AMERICAN FORK CITY DEVELOPMENT REVIEW COMMITTEE AGENDA

**Regular Session
March 31, 2025
Monday 10:00 AM**

Review and action on an application for a Final Plat, known as Bridges at Fox Hollow Plat “C”, located at approximately 1040 N 400 E, American Fork City. The Final Plat will be in the Planned Residential (PR-3.0) Zone.

BRIDGES AT FOX HOLLOW PLAT "C"

SHEET NAME	SHEET NUMBER
1080 NORTH PLAN & PROFILE	C8.0

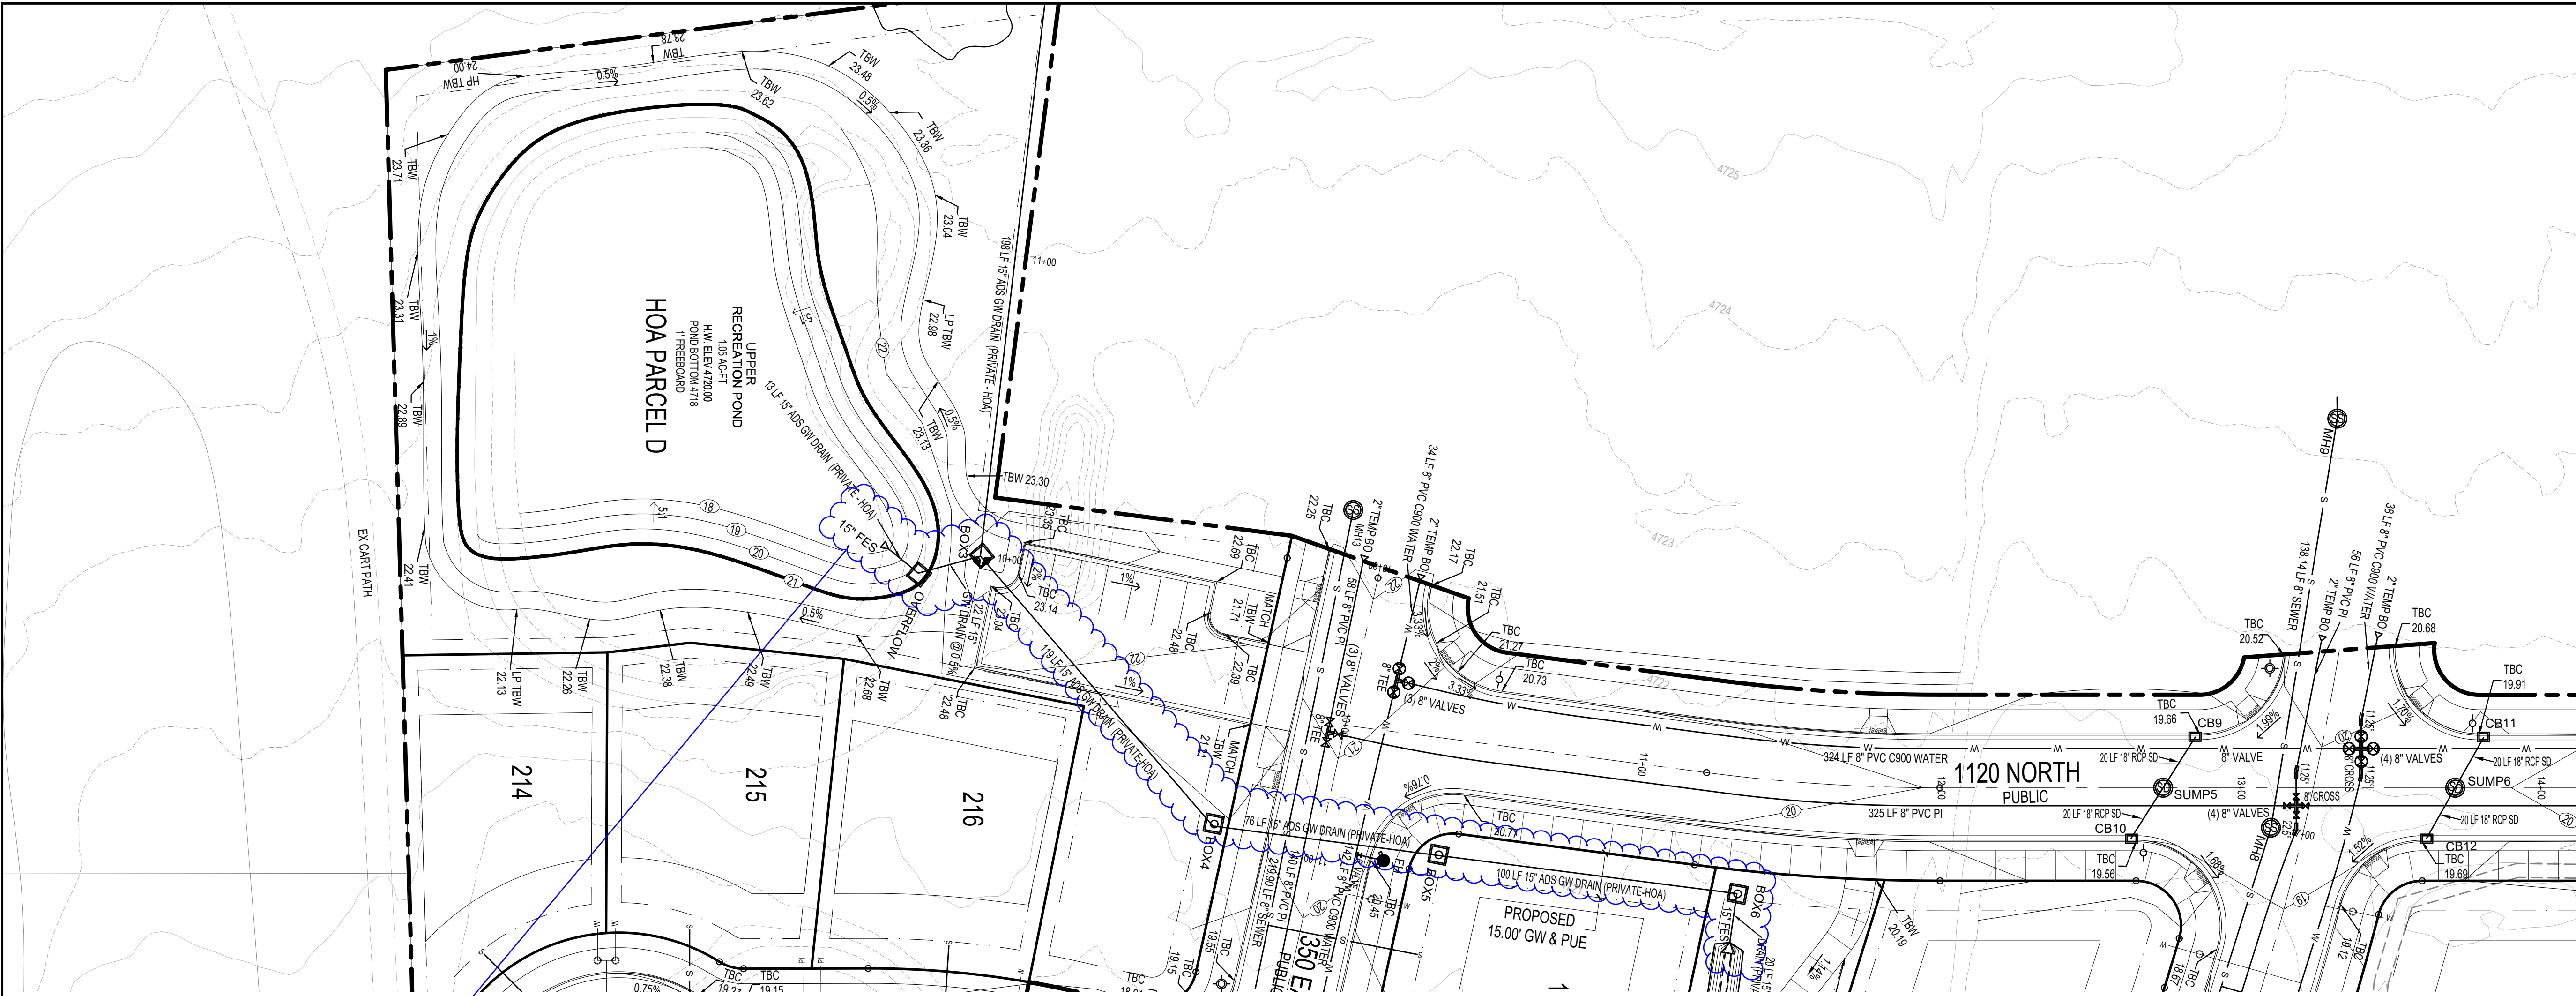
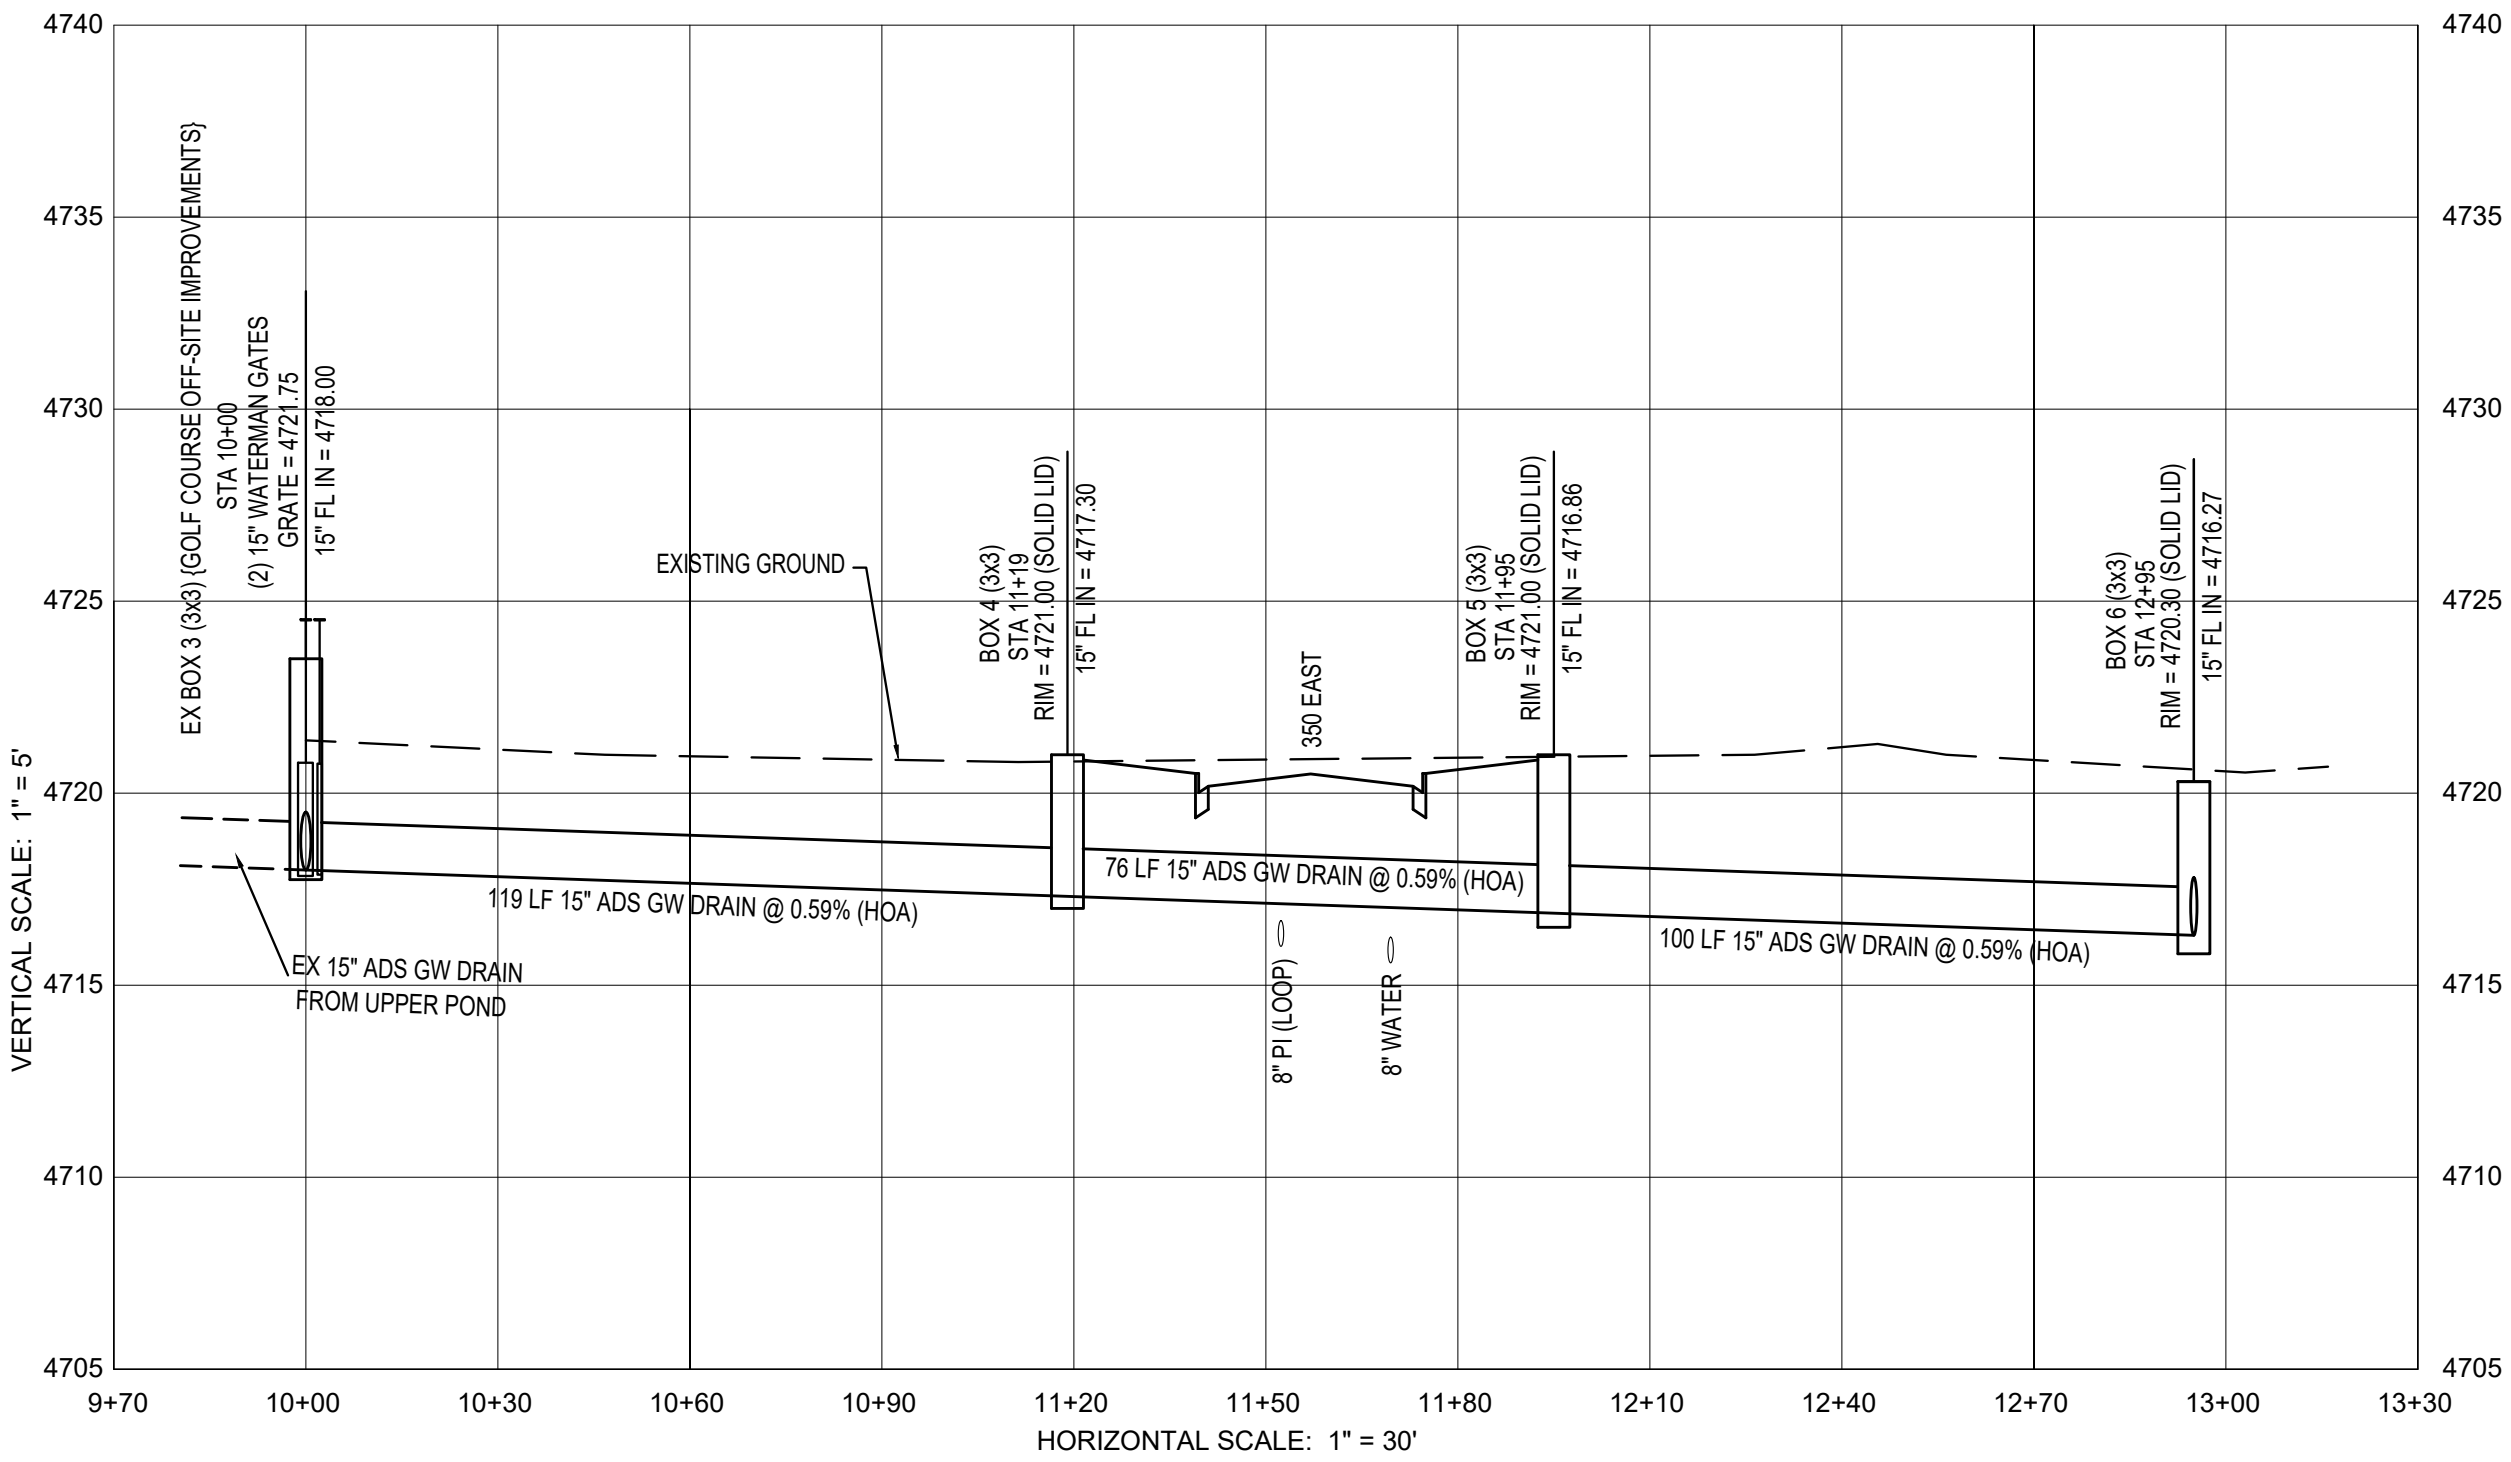
Previously shown as
a 18" ADS pipe.

Do calculations
support this change?
